## APPLICATION FOR SUBMITTAL OF POST-APPROVAL DOCUMENT

**ADDENDUM NO. 1**  
**PROJECT MANUAL**  
**MLK ELEMENTARY SCHOOL**  
**PARENT CENTER**  
**BAKERSFIELD CITY SCHOOL DISTRICT**

**Project No.: 5528**  
**DSA File No. 15-6**  
**DSA App No. 03-122604**  
**December 19, 2024**

Job No.: **5528**  
Sheet No.: **C1.1**

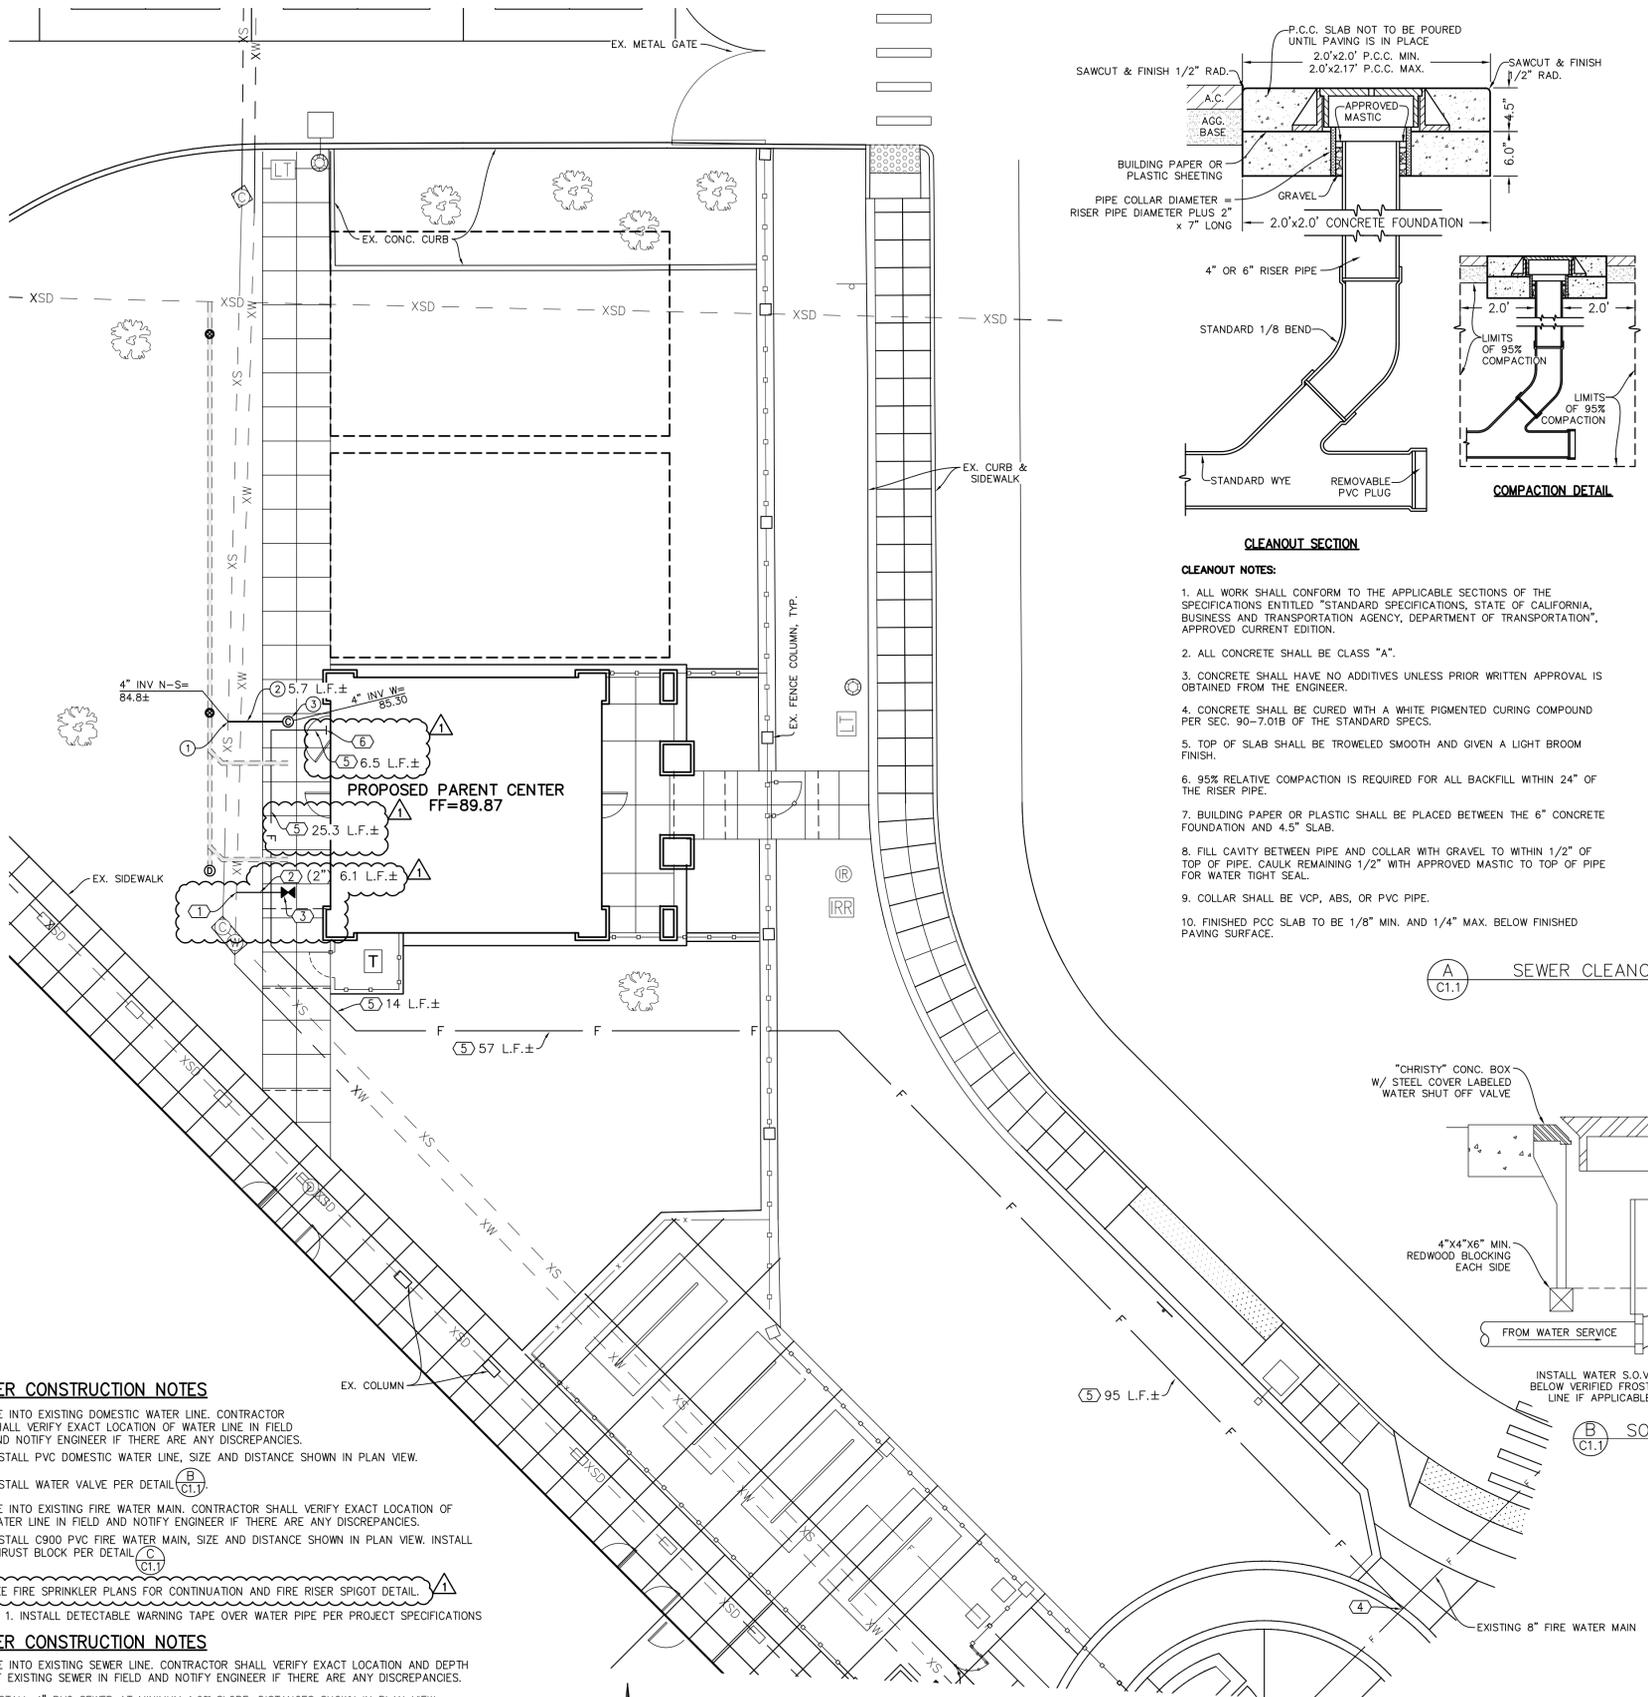
- 1-08 **DRAWING, SHEET C1.0 – GRADING PLAN:** Note the following changes (see C1.0 addendum 1 drawing):
  - 1. Utility yard has been added to the Southwest corner of the building.
- 1-09 **DRAWING, SHEET C1.1 – SEWER AND WATER PLAN:** Not the following changes (See C1.1 addendum 1 drawing):
  - 1. Water point of connect has changed.
  - 2. Utility yard has been added to Southwest corner of the building.

Sheet No.: **L1.01**

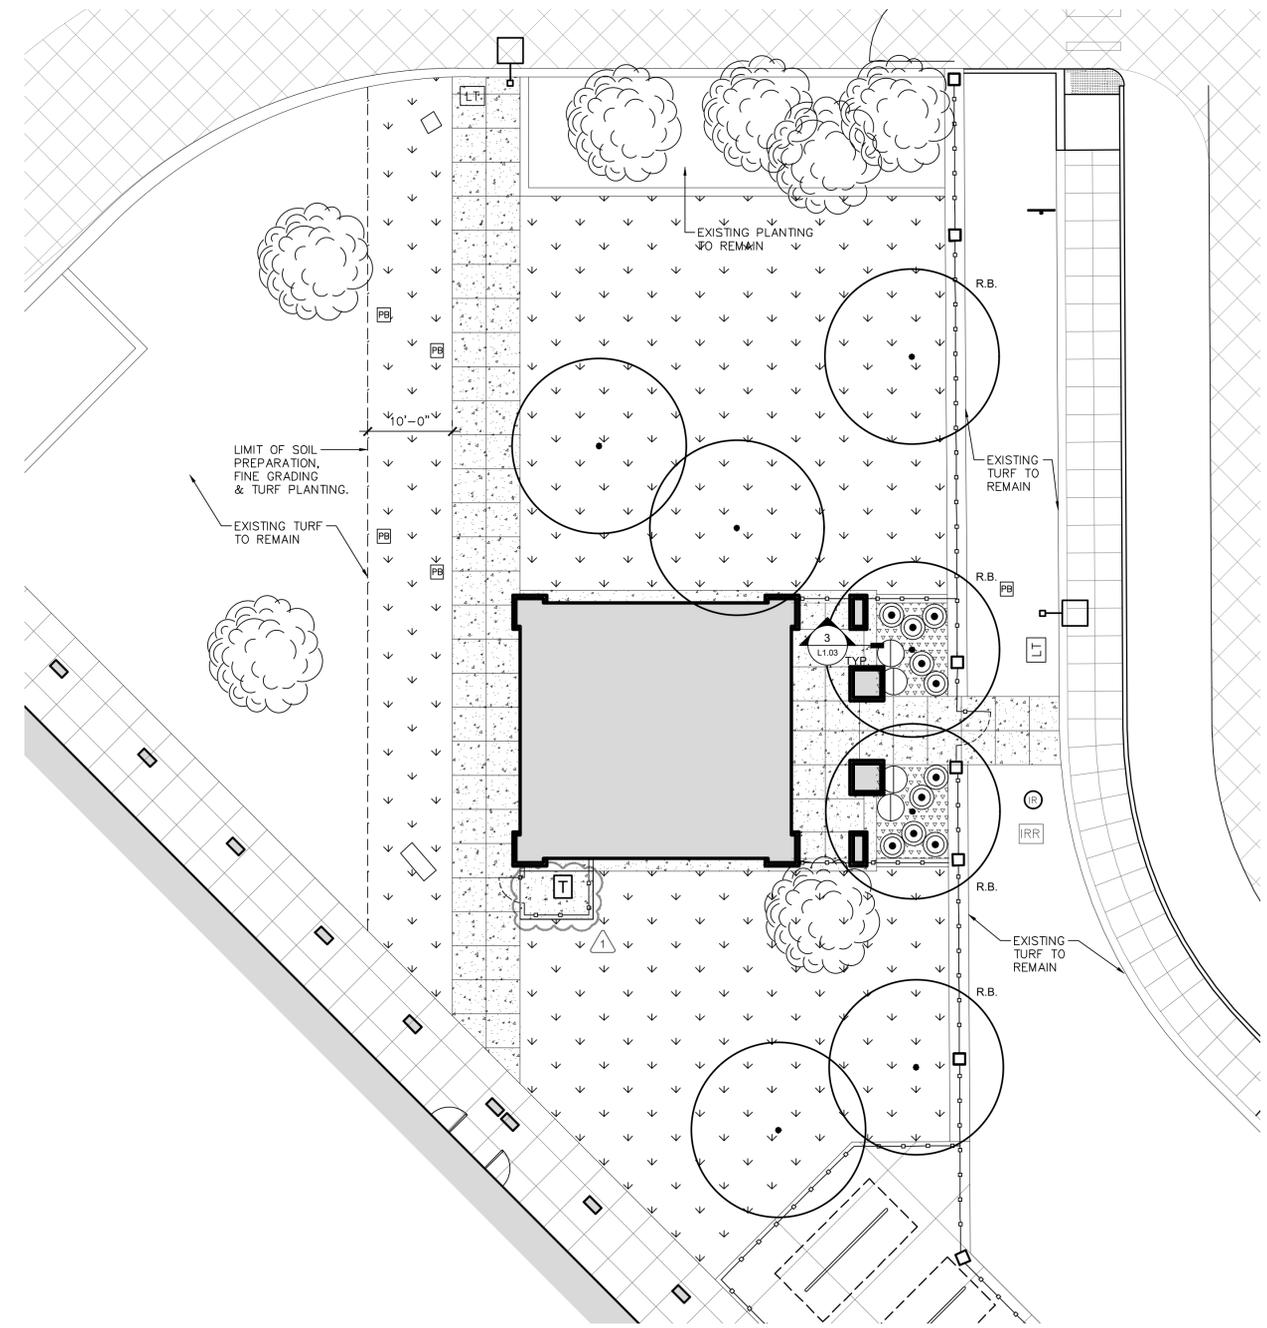
- 1-10 **DRAWING, SHEET L1.01 – LANDSCAPE PLAN:** Plan has been updated to show utility yard at Southwest corner of the building. (See L1.01 addendum 1 Drawing):

Sheet No.: **L1.02**

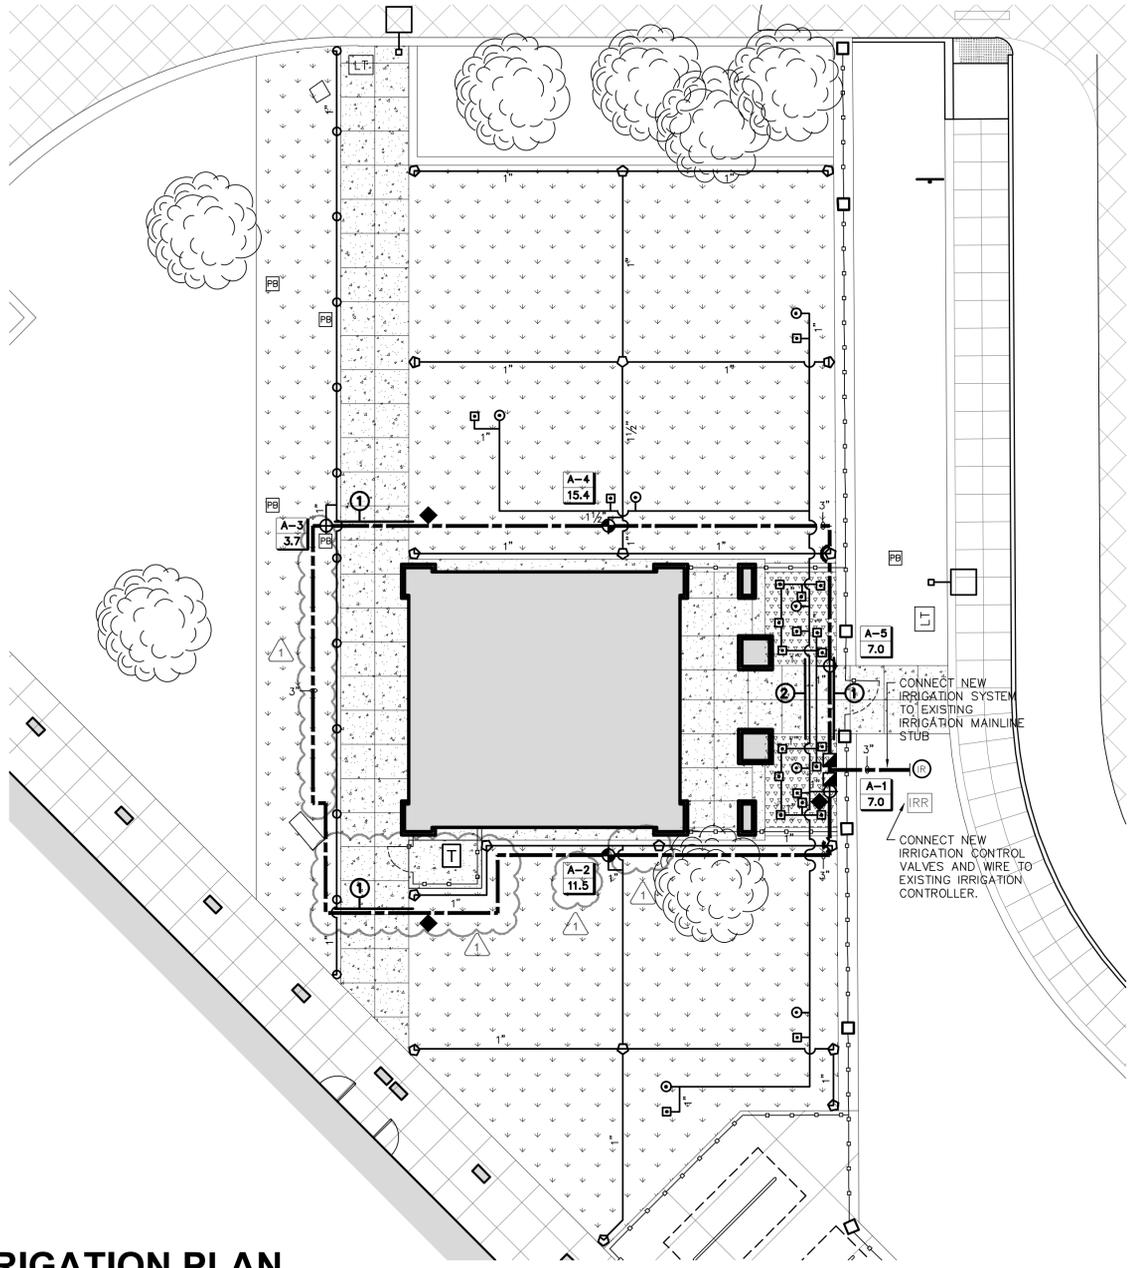
- 1-11 **DRAWING, SHEET L1.02 – IRRIGATION PLAN:** Plan has been updated to show utility yard at Southwest corner of the building. Irrigation line has been adjusted accordingly. See L1.02 addendum 1 drawing

Sheet No.:  
**A0.01**

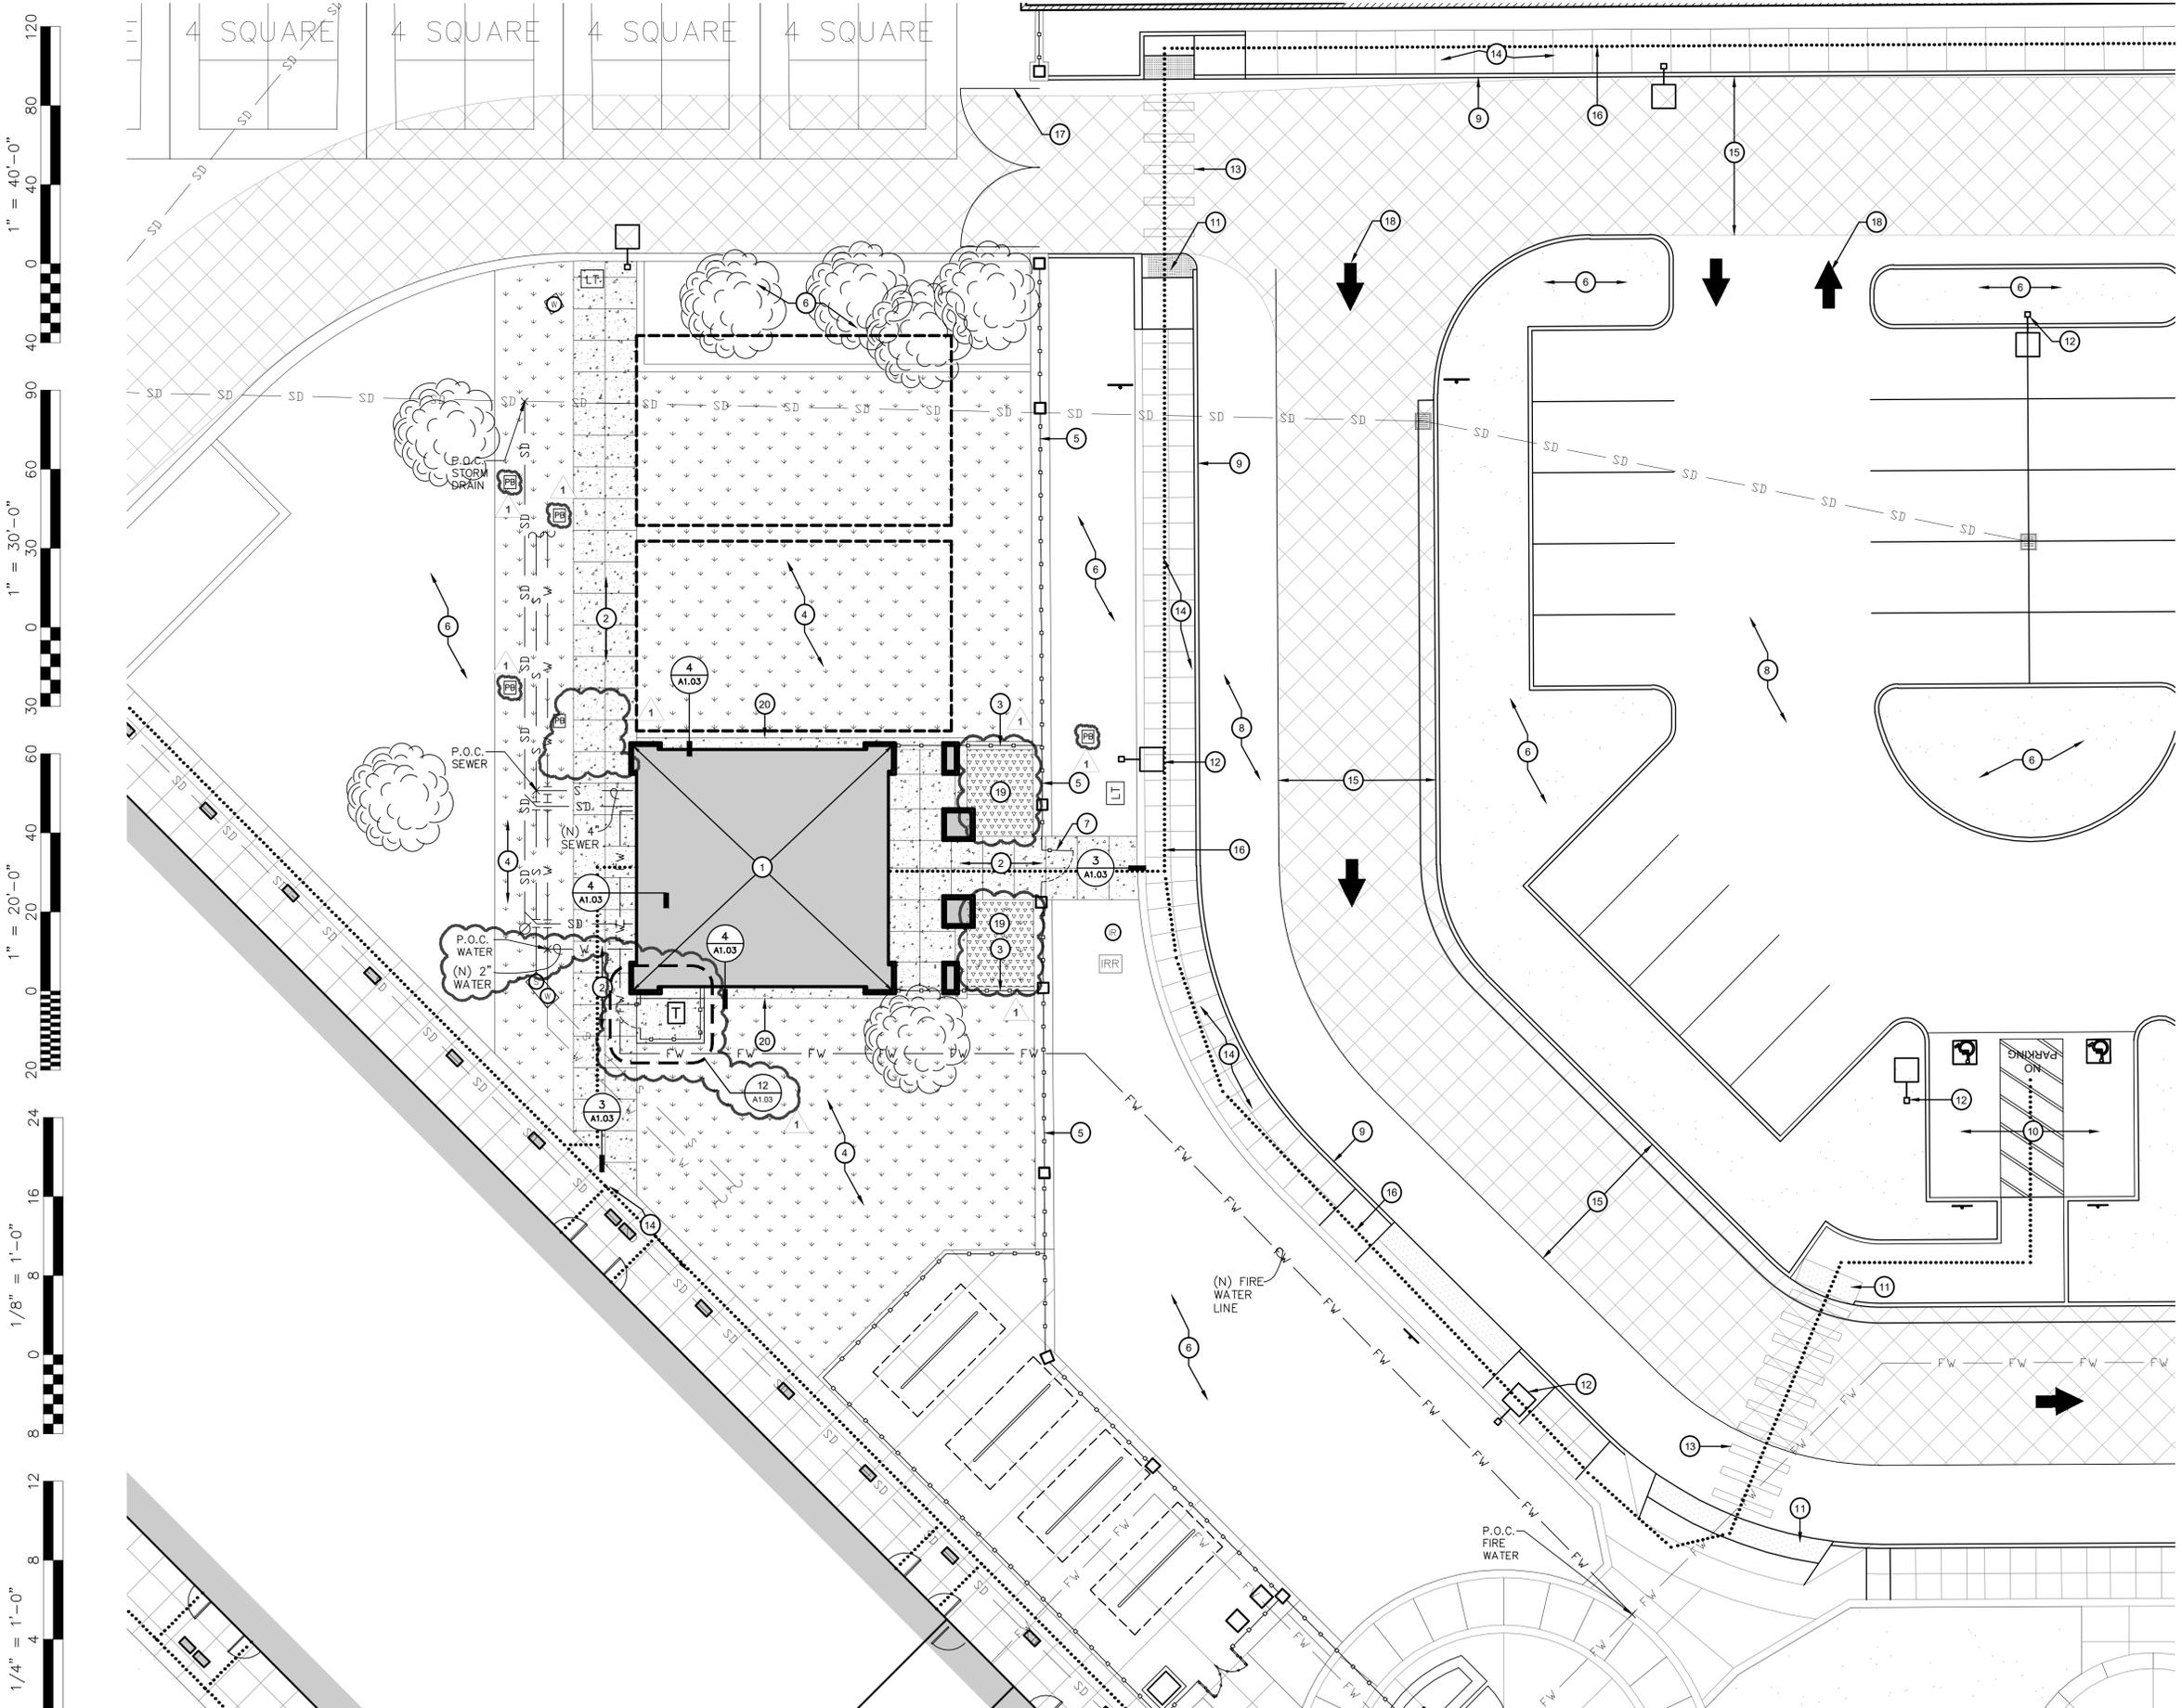
- 1-12 **DRAWING, SHEET A0.01 – SCHEDULES:** Note the following changes (See A0.01 Addendum 1 drawing):

1. Mag locks added to doors 101A and 101B
2. Walk off carpet tiles are added to room 101-see floor plan for locations
3. Add plywood over GYP board in room 103. On the North and East walls.
4. Add plywood to the abbreviations.
5. Change ceiling height to 9'-0" in room 103.

**13 DECORATIVE STEEL SINGLE GATE**  
 A1.03 ADS100-53 SCALE: 3/8" = 1'-0"

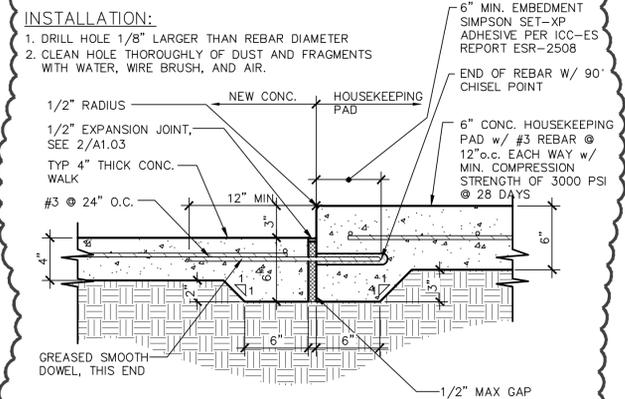
1. Add detail 12/A1.03 for new utility yard.
2. Add detail 13/A1.03 for new decorative gate.
3. Add detail 14/A1.03 for new housekeeping pad.

**12 ELECTRICAL YARD**  
 A1.03 ADS000-03 SCALE: 3/8" = 1'-0"

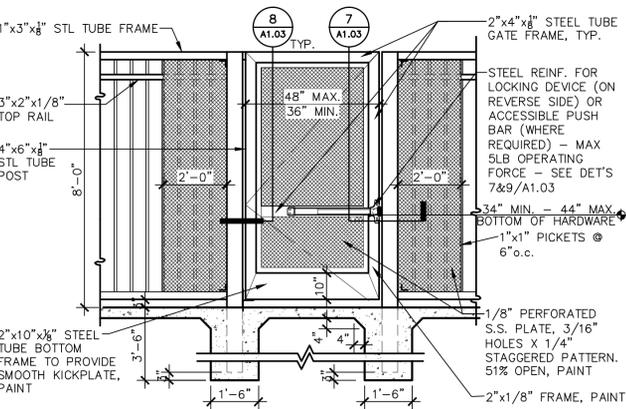
- 1-14 **DRAWING, SHEET A1.03 – SITE DETAILS:** Note the following changes (See A1.03 Addendum 1 drawing):
